ADDENDUM NO. 02:

PROJECT: CENTRAL OFFICE BOARD ROOM A/V EQUIPMENT UPGRADES
BID NO: 20F-113
CLIENT: FAIRFIELD-SUISUN UNIFIED SCHOOL DISTRICT

FROM: MADI Group, Inc.

- ITEM 1: Drawing AV102.01 is revised as shown below:

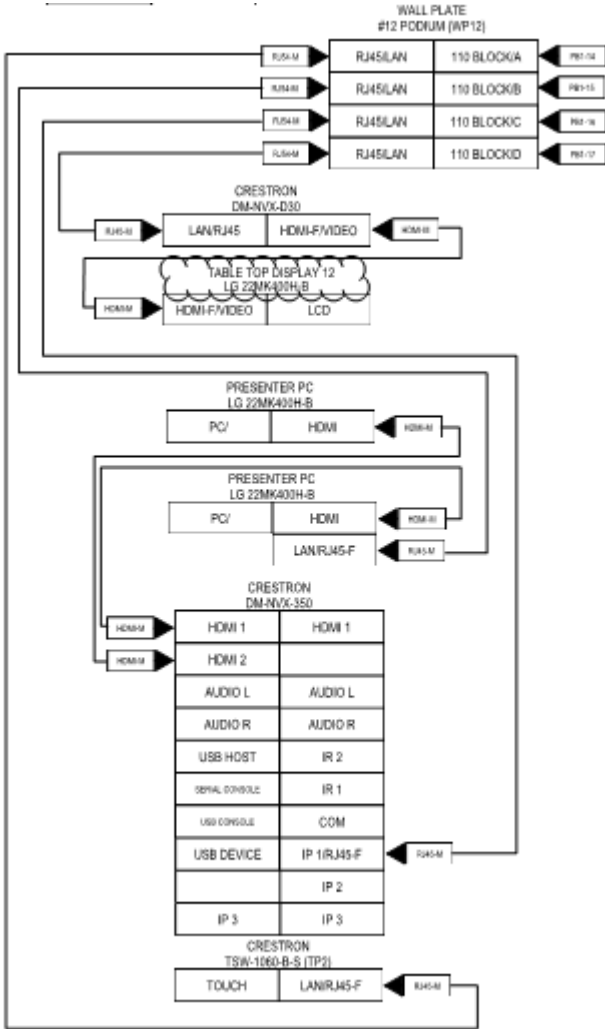
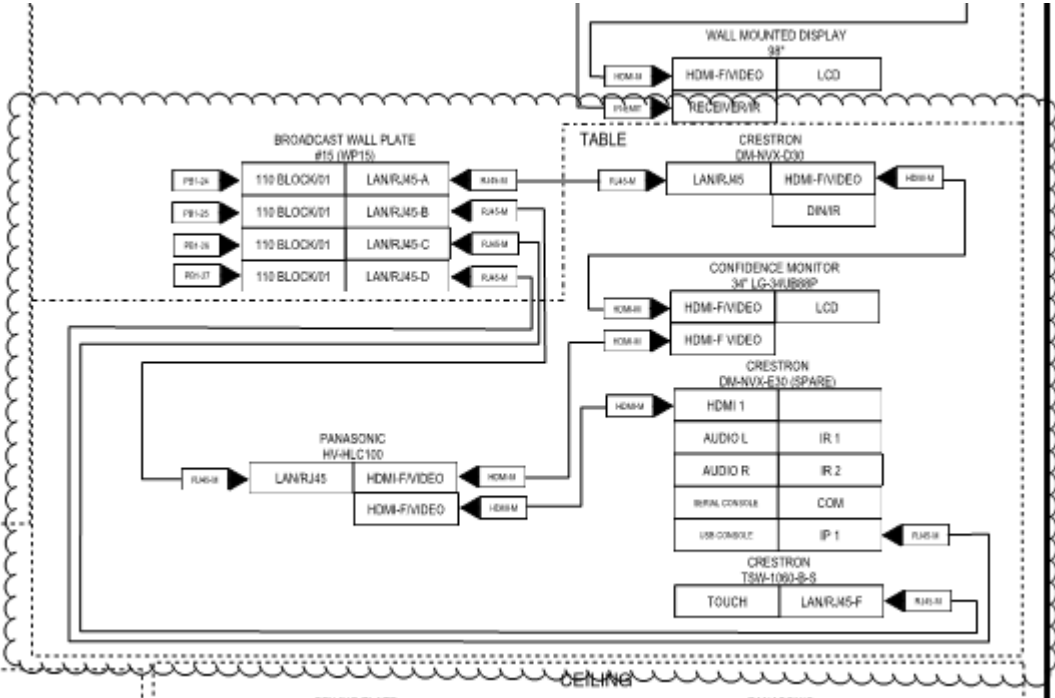
QUESTION 4: Please provide the location of the wireless microphone system antenna. It is currently not shown on the room layouts.

RESPONSE 4: See Section B ITEM 1 above.
